Burnham Laboratory, BioSciences II, Bldg 571  
Project No. FM060653S/981510

**Addendum No. 1**

March 2, 2007

ADDENDUM NUMBER 1

AD-1

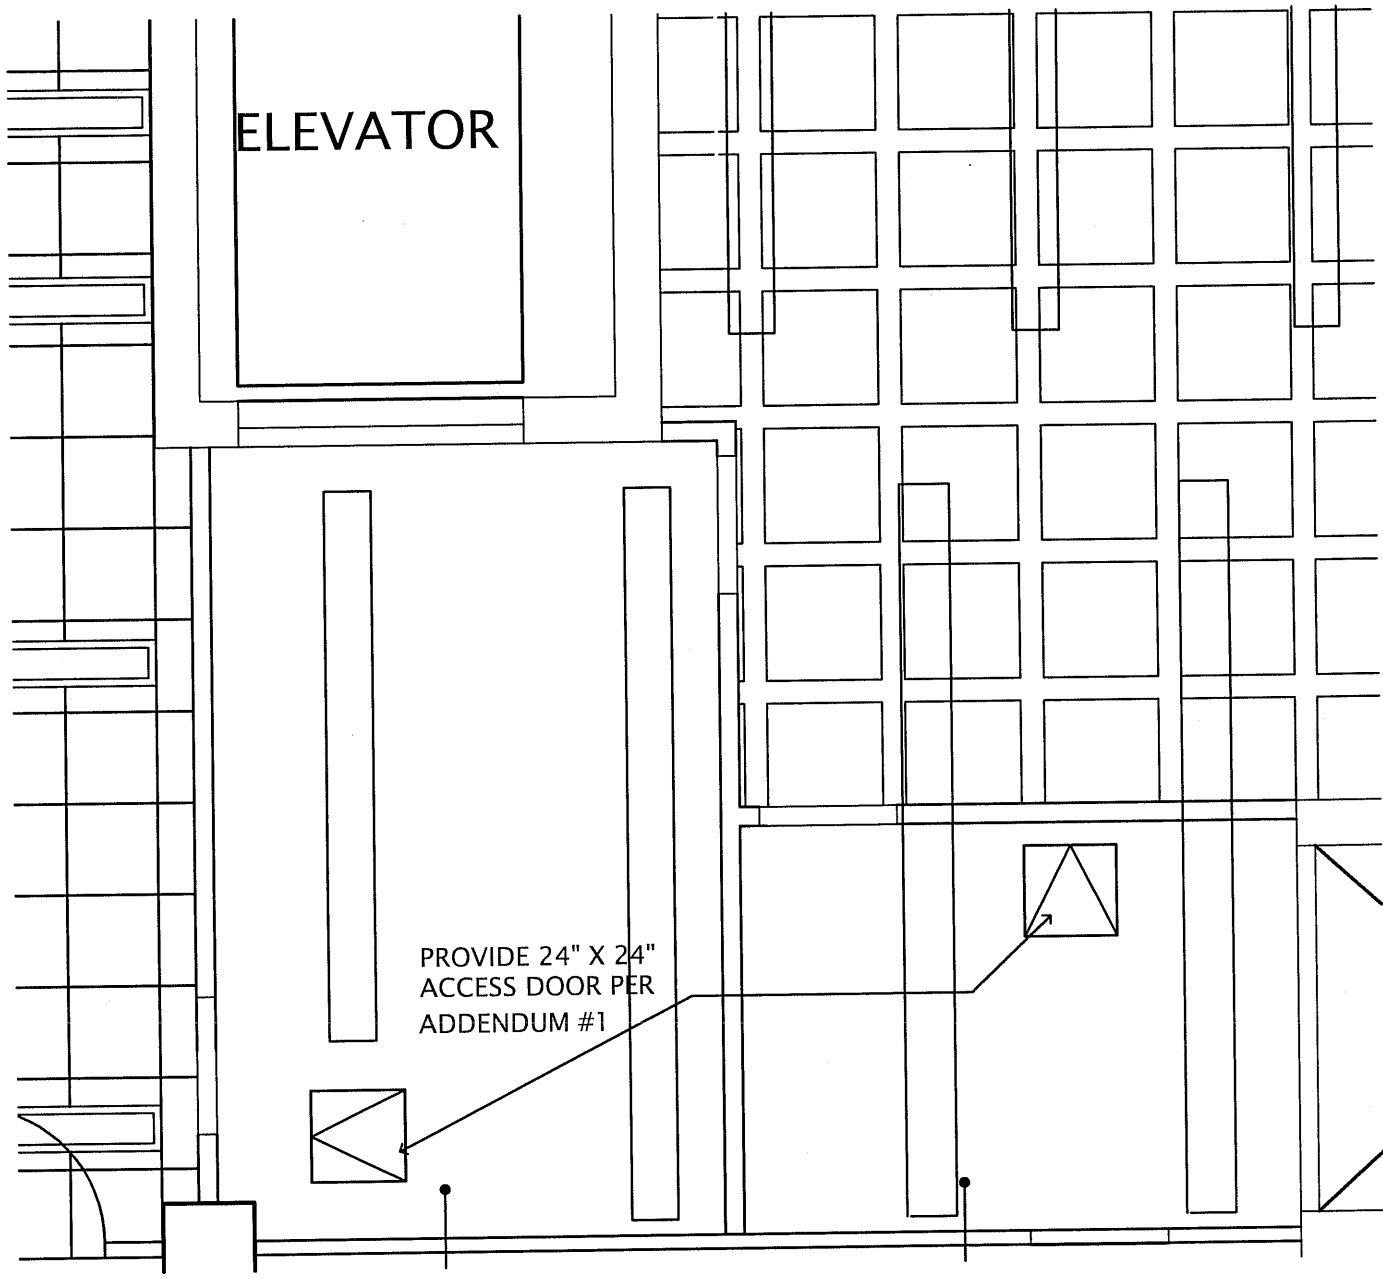
1. DRAWING NO. A2.0 (DEMOLITION PLAN); **Add** the following keynote:  
"13. Removal and erection of wall between Rooms 3121 and 3123 shall be conducted on a scheduled weekend. Plastic sheeting shall be used to protect office contents."
2. DRAWING NO. A2.1 (PARTIAL FLOOR PLAN); " Room 3115 "; Provide furred out wall per attached Drawing **AD-1** to accommodate heating piping shown on sheet P2.2.
